TUALATIN ARCHITECTURAL REVIEW BOARD

**MEMORANDUM
CITY OF TUALATIN**

SUBJECT: Amended Nyberg Rivers Recommendation for AR-13-07 based on December 3rd Hearing

Consideration of a request to allow the development of a shopping center. Center Cal, LLC proposes developing an approximately 300,000 square foot shopping center. The purpose of the December 16th meeting is for the Architectural Review Board to deliberate and make a decision.

Cabela's Rear Elevation Enhancements--Tualatin

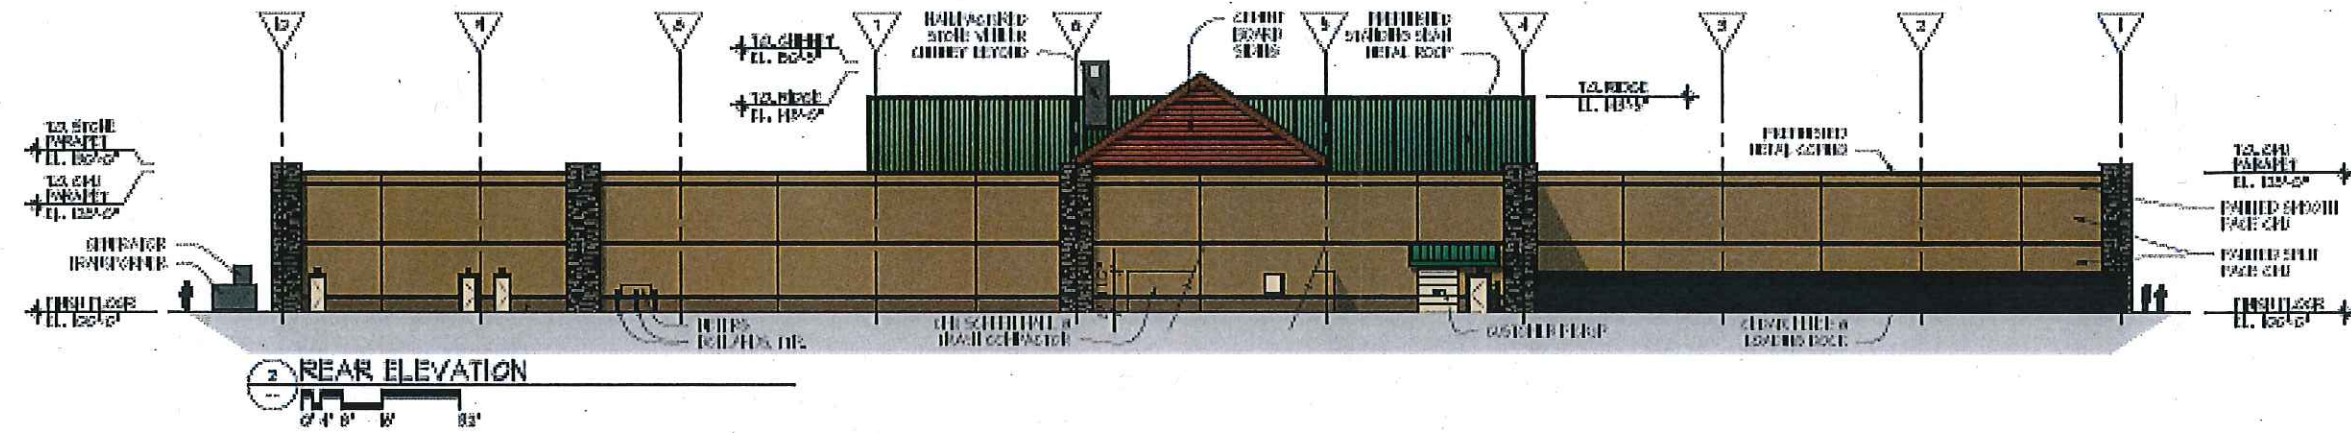
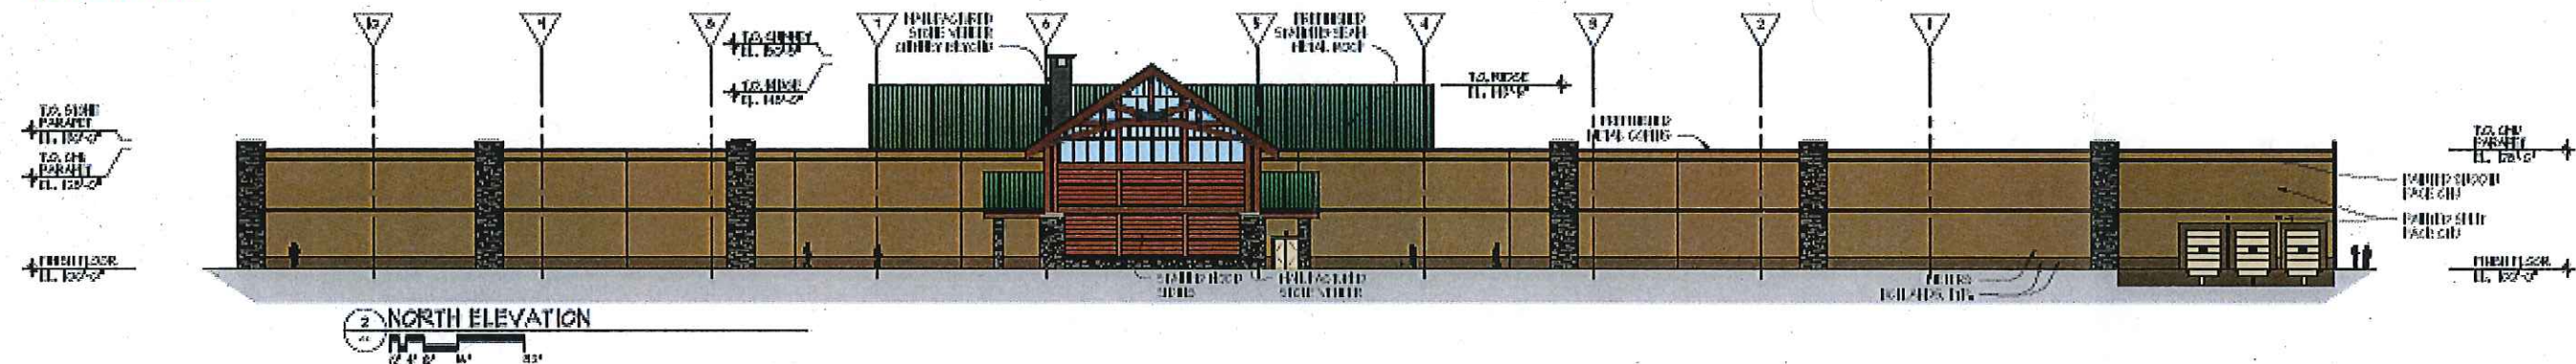
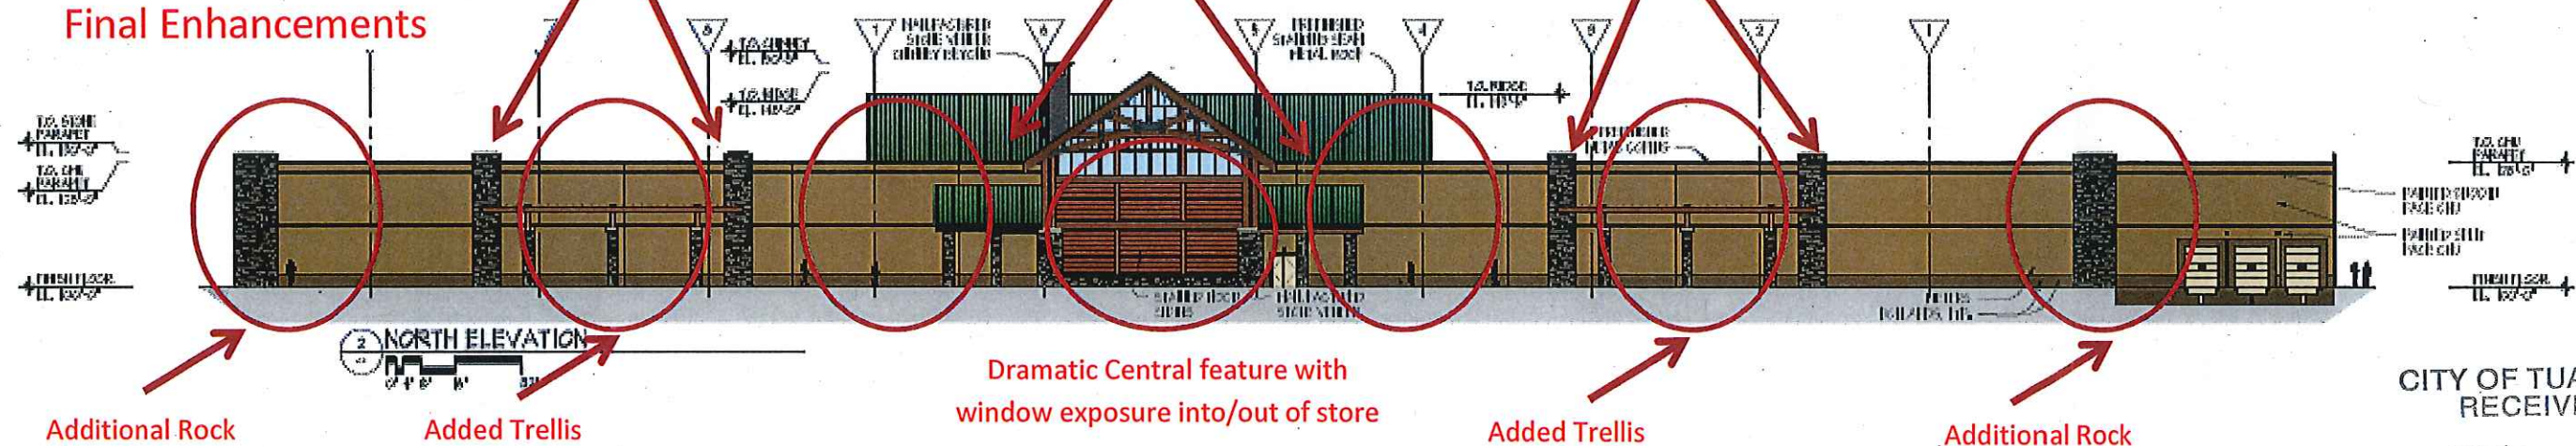
Additional rock pilasters

Extended shed roof

Additional rock pilasters

Final Enhancements

Architecture on Cabela's

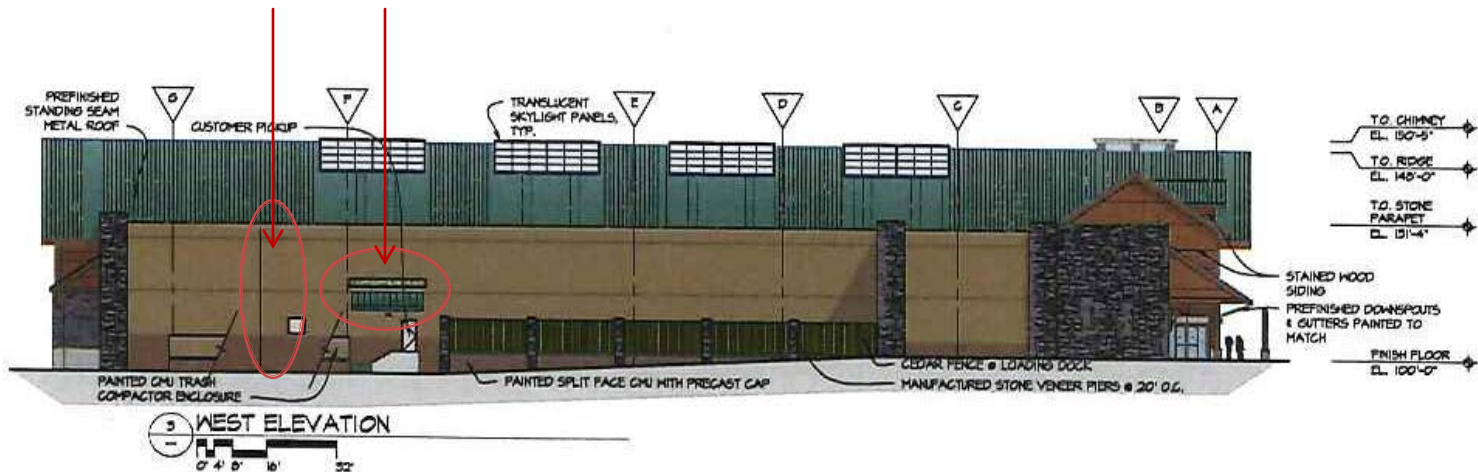
The applicant shall also add the architectural features shown in the picture below to all sides and all corners of the building as proposed on during the master plan on Exhibit P of the June 3 Addendum.

Architecture on Cabela's

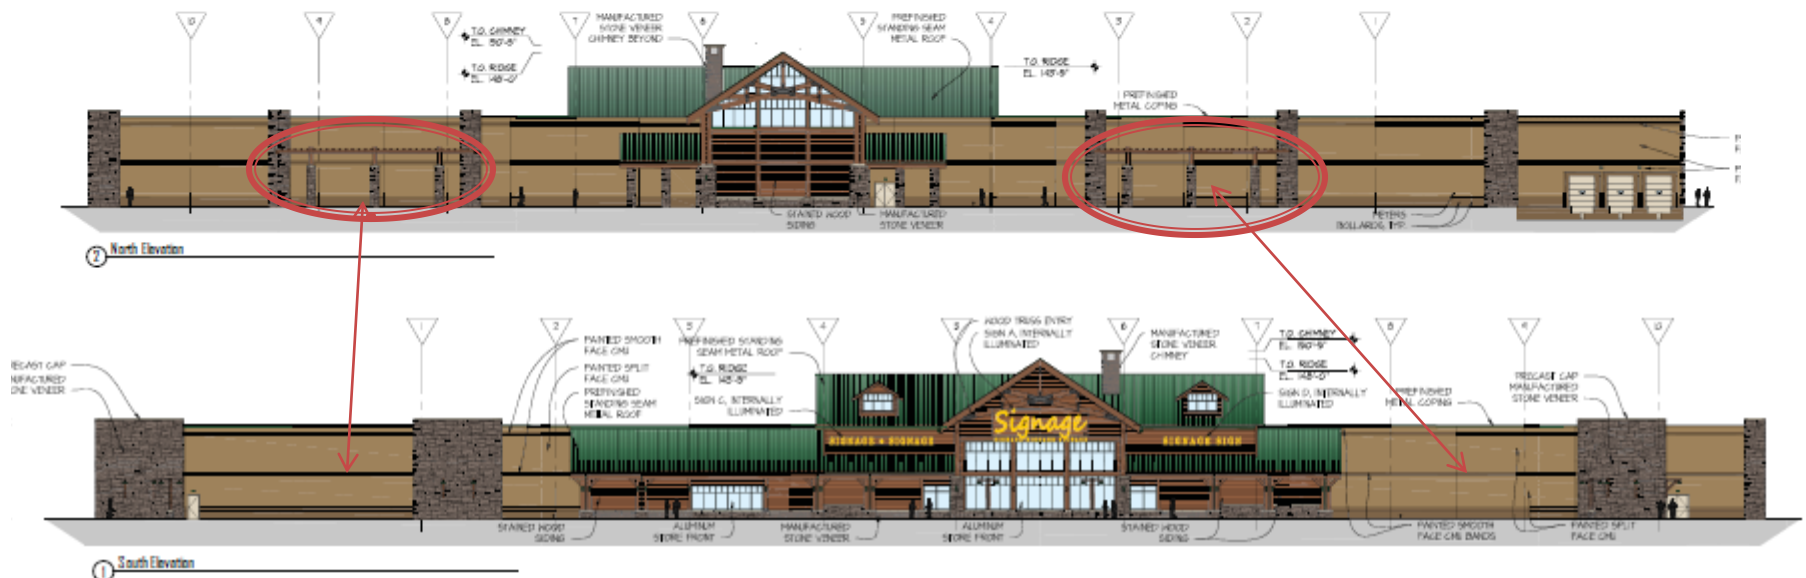
In addition the Cabela's building shall also add the trellises shown on the north side of Cabela's on page A3.10a of the complete plan set intake stamped date November 12, 2013 to the south side of the building. These trellises shall be 62-feet wide, 18-feet in height, and have three stone veneer columns exactly like the trellises shown on the north side of the building.
